Technical Review Board

Our Ref: TRB.L26

TRB Recommendations RE: PSM Hazelwood Northern Batter Movement Report

TRB RECOMMENDATIONS RE: PSM HAZELWOOD NORTHERN BATTER MOVEMENT REPORT

Figure 1: Reproduction of Figure 29 of PSM Report Showing Cracks and Movements in the Northern Batter

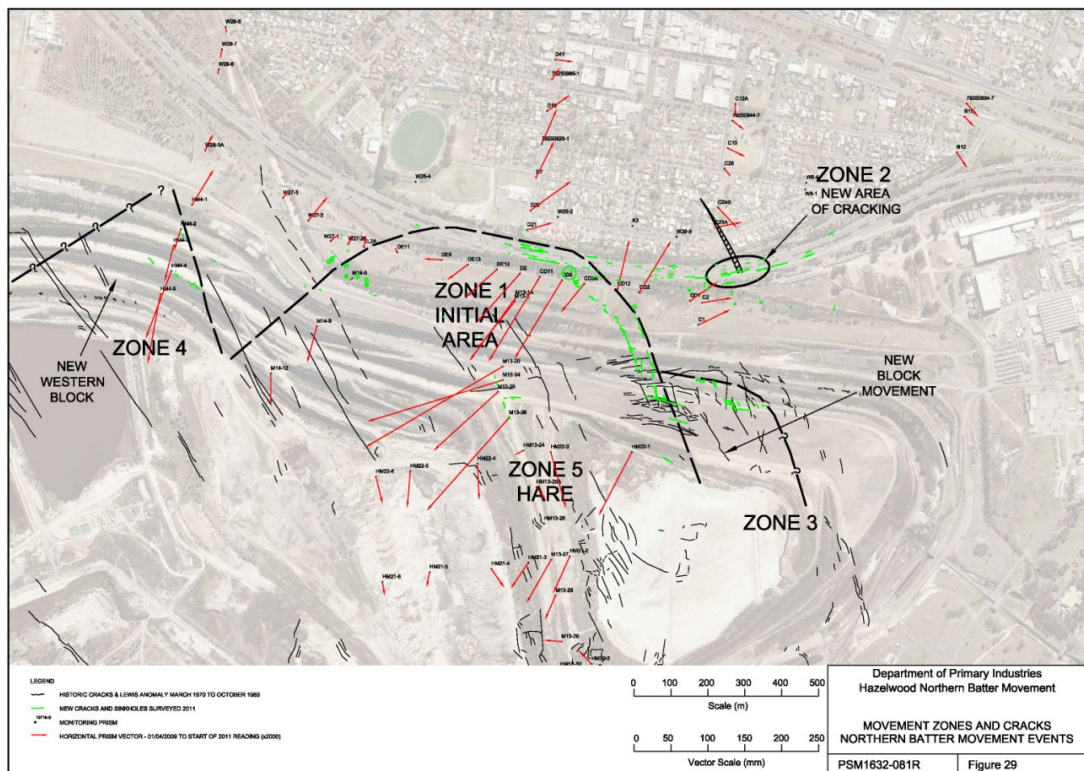
The TRB accepts that Figure 29 of the PSM Report, reproduced as Figure 1 in this report, generally depicts the current state of movement and cracking in the vicinity of the Northern Batters. The TRB is concerned by the extent of movement and cracking. It is in agreement with the PSM Report that:

“The rainfall on the 4th and 5th February 2011 was only a 1 in one year event and of itself could not have caused the Northern Batter Movement.”

Figure 2: Reproduction of Figure 17 of PSM Report Showing Current and Historic Cracks and Sinkholes

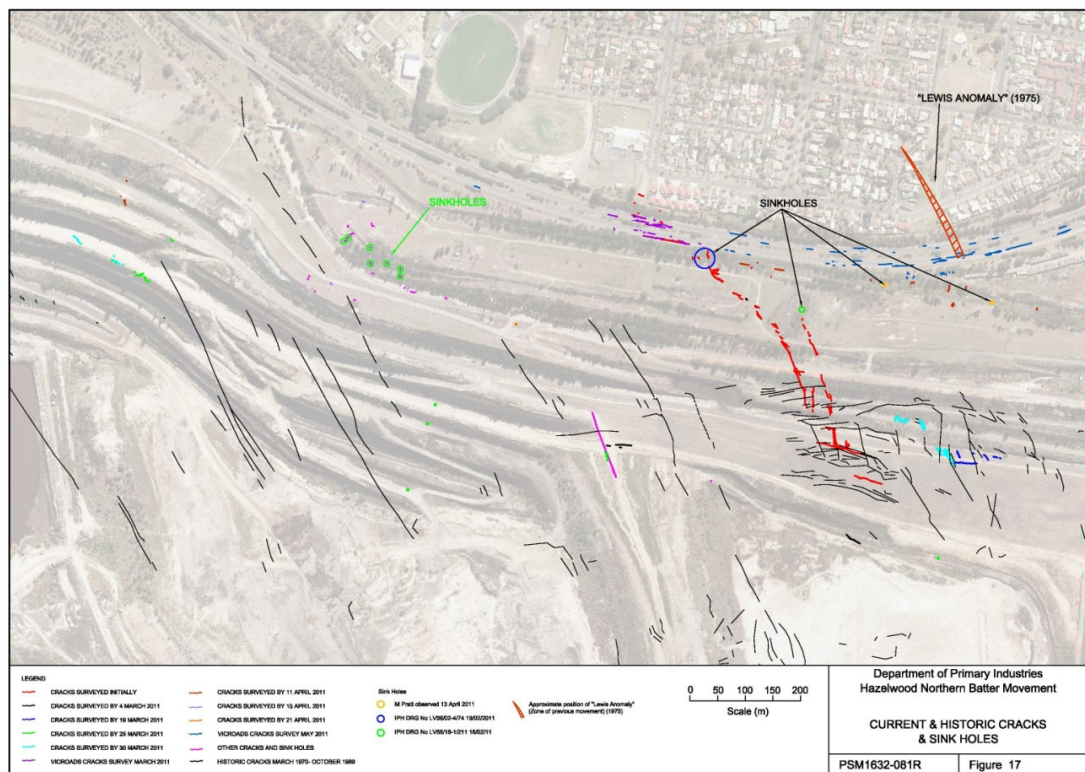
The drain is described in the PSM Report as having received “... *no remediation for the last two decades*” as well as being “*in a poor state with extensive shrub and tree growth*”. It is also stated “*one sinkhole started forming in 2007 and some repair works were reported*” and “*other sinkholes were reported in 2009*”. Further to the above, according to plans showing the location of historic cracks and sinkholes, Figure 2 (reproduced from Figure 17 of the PSM Report), there is a likelihood that more cracks and sinkholes had developed in the MMD by this time but were not observed because of the vegetation cover.

Figure 3: Reproduction of Figure 25 of PSM Report Showing Long Term Settlement Rates

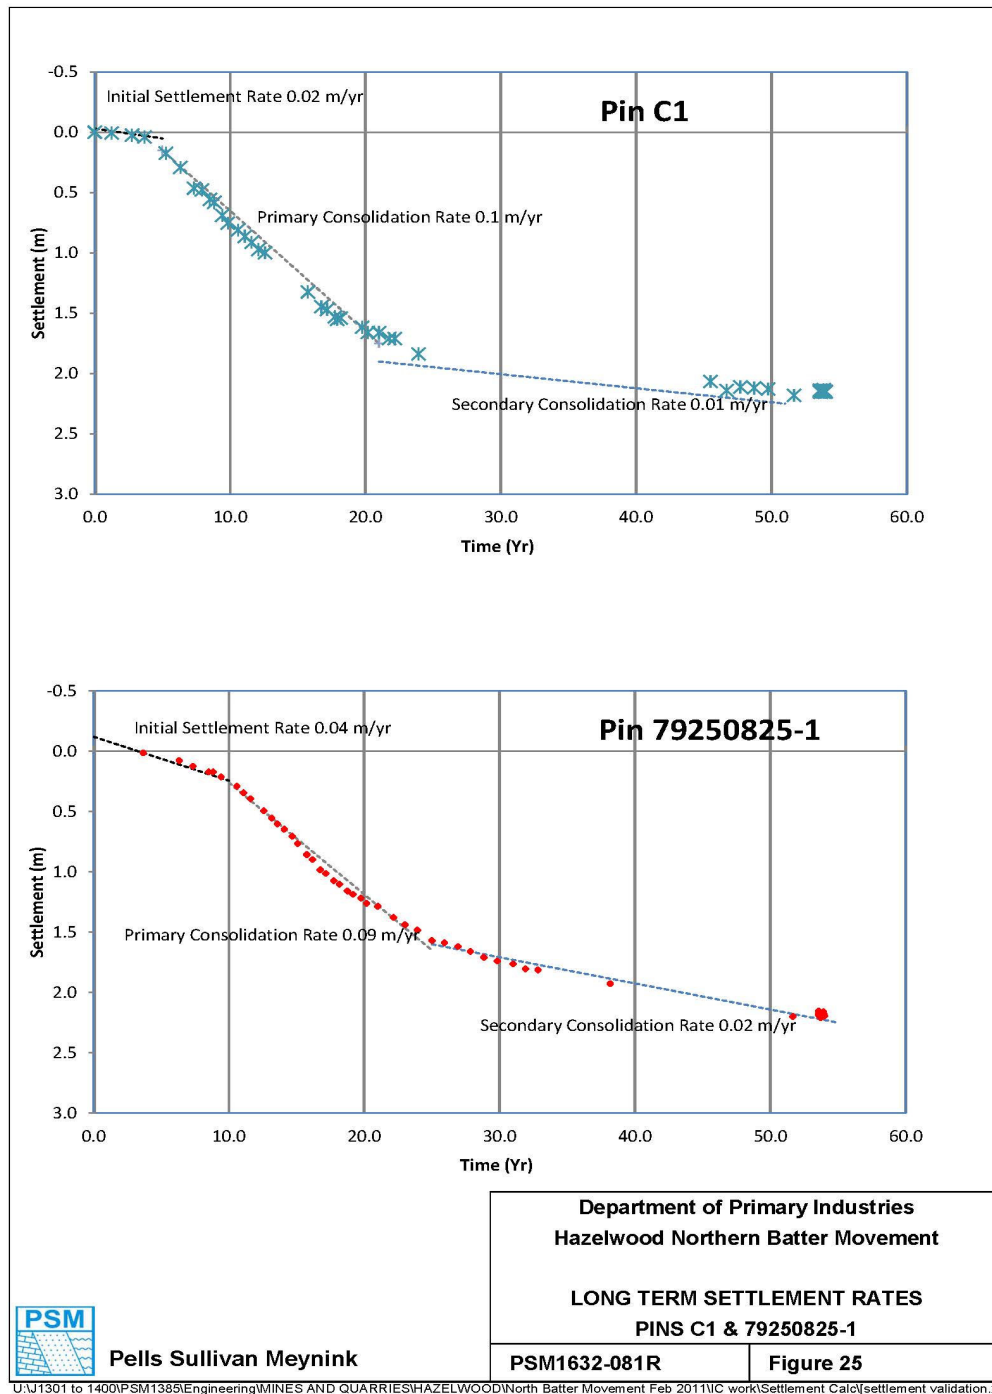
With regard to the re-initiation of primary consolidation, the evidence presented in the PSM Report in support of this conclusion is sparse. The long term settlements for two pins and their corresponding rates are presented in Figure 3 (reproduced from Figure 25 in the PSM Report).

The PSM Report suggests that because the general shape of the two curves shown in Figure 3 is similar to a classical consolidation response curve for a compressible soft clay, consolidation accounts for the long term response of the Northern Batter. However, it is the view of the TRB that this would only apply if the water pressures driving the consolidation process were reduced at the commencement of consolidation and held constant thereafter. In reality, there have been many ongoing significant and complex water pressure changes within the two main aquifers, as shown in Figure 4, suggesting to the TRB that the shape of these two particular long term settlement curves and their similarity with the classical consolidation curve is largely coincidental.

There are several other elements of data offered in the PSM Report as support for the concept of re-initiation of consolidation. One such data set involves pin settlement rates compared with the implied rates of settlement for the two main components of settlement from Figure 3; around 0.1 m/yr typical for primary consolidation and 0.01 to 0.02 m/yr for secondary consolidation. While this is supported by some pins, there seems to be several other pins which should be similarly affected but which show considerably different results.
